INITIAL FIRE SAFETY INSPECTION REPORT

SAIHAM KNIT COMPOSITE LTD. (Extension Area)

Factory ID: 24022

Date: 25 February and 02 June 2021

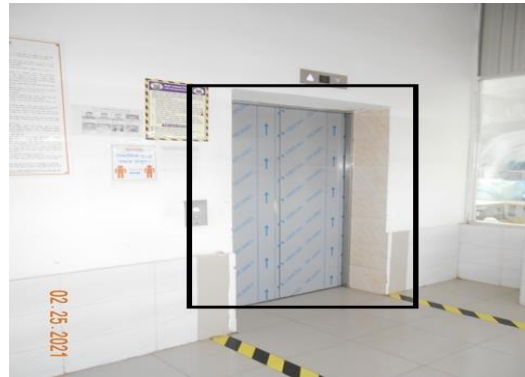
SI No.	Category	Findings	Required Action	Remediation Time Frame
F-1	Fire-Rated Construction	The exit stairs are separated from work areas & other spaces on each floor by fire rated construction and fire door except ramp, one opening at stair-4,non rated glass from machine room to stair-5 on ground floor (building-1). Also magnetic door holders were missed installed door (building-1,3 & 4)	Stair shall be enclosed with a minimum 2-hr fire-rated construction. Seal all unprotected openings and provide minimum 1.5 -hr. fire rated doors to separate the exit stairs from work areas and other building spaces on all floor levels. Ensure that the fire doors are self-closing, positive latching and that they are provided with fire exit (panic) hardware where serving production floors. If fire doors are required to be held open for functional reasons, provide automatic-closing devices tied to the fire alarm system.	Within 3 months

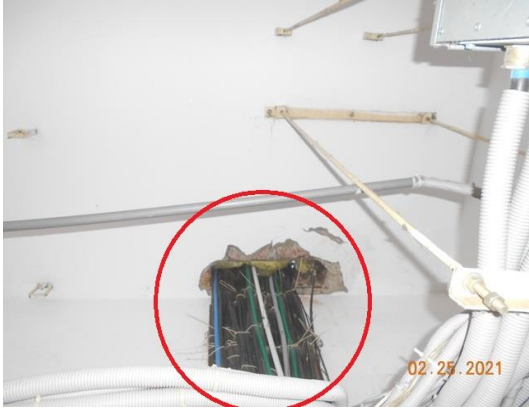
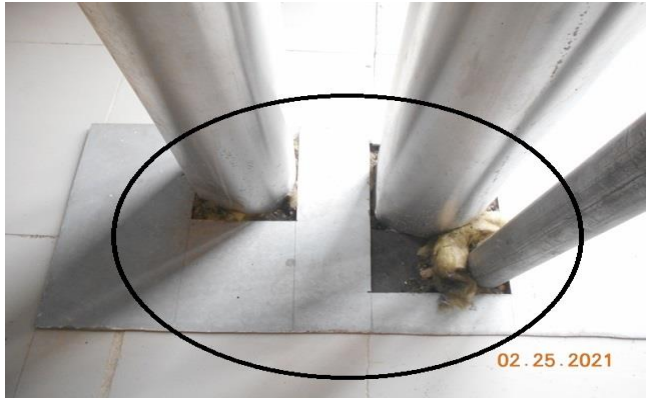
F-3	Fire Rated Construction	Elevator is discharge inside the each production floor. Location: South side of the building-1.	Provide a minimum 2-hr fire rated elevator shaft to separate it from each floor. Seal and/or protect all openings to maintain fire separations	Within 3 months

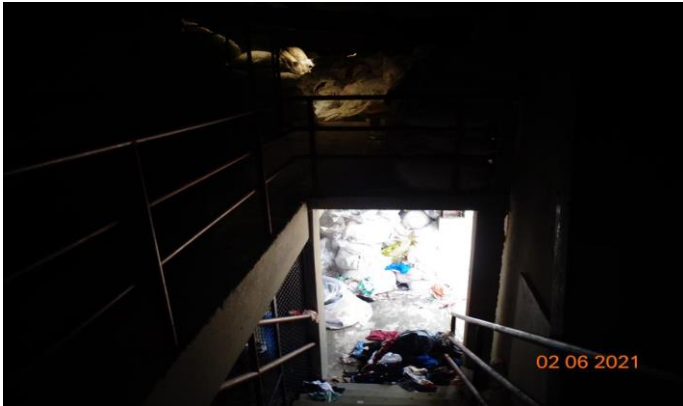
F-9	Fire-Rated Construction	The exit discharge path is less than 10ft. wide and is not separated from the suction machine room (the West exit on building-1) and building interior glass window (the East exit of the building-4 at stair-3) and south side of building 5(printing)	Seal all penetrations and openings to the interior of the building along the discharge path, up to a height of 10 ft, to provide a minimum 1-hr fire separation. Alternatively, provide a second remote discharge path to the public way (only include this if feasible).	Within 6 months

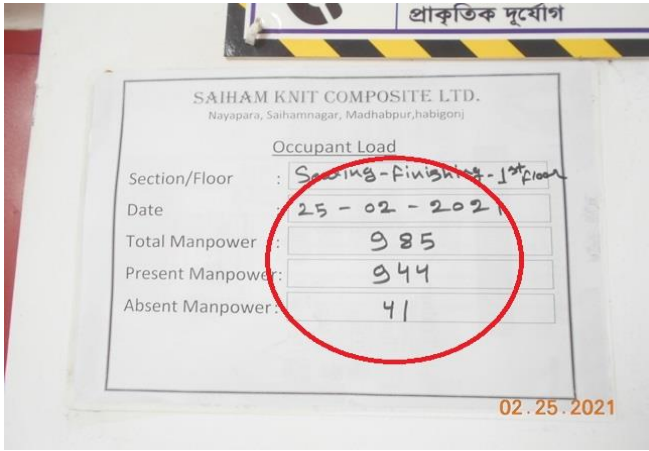
F-12	Fire Rated Construction	Exit stair(s) is discharge inside the ground floor storage area in the building 11. Location: Building11(wastage godown)	1. Modify stair to discharge directly outside. Or 2. Provide 2-hr fire-rated exit passageway leading directly outside (vestibules to separate any storage areas). Or 3. Provide sprinkler protection for discharge floor in accordance with NFPA 13.	Within 3 months
